Access Compliance Report Public Rights-of-Way (Curb Ramps)

Main Street: RISA_PL Cross Street: ARROYO_AVE Location: S

ADA ID: RPRK211012122522 Ramp Type: Type 4 - Parallel Initial Pass/Fail: Fail Overall Compliance: No Severity Score: 30

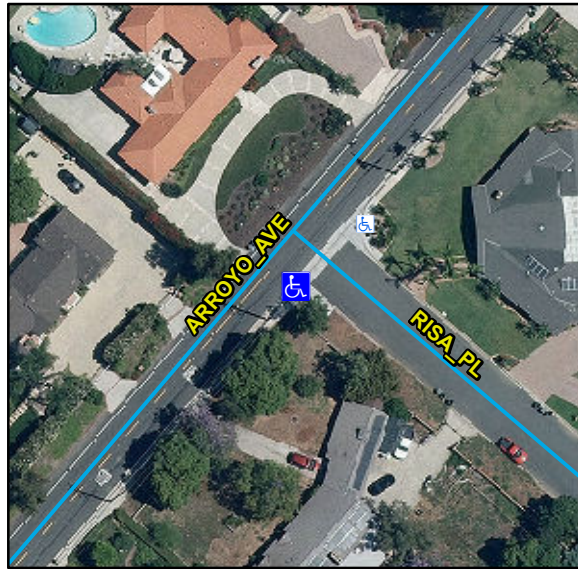
R304.5.3, STD 1115

Remove & Replace Curb Ramp With Two New Directional Ramps or Equivalent.
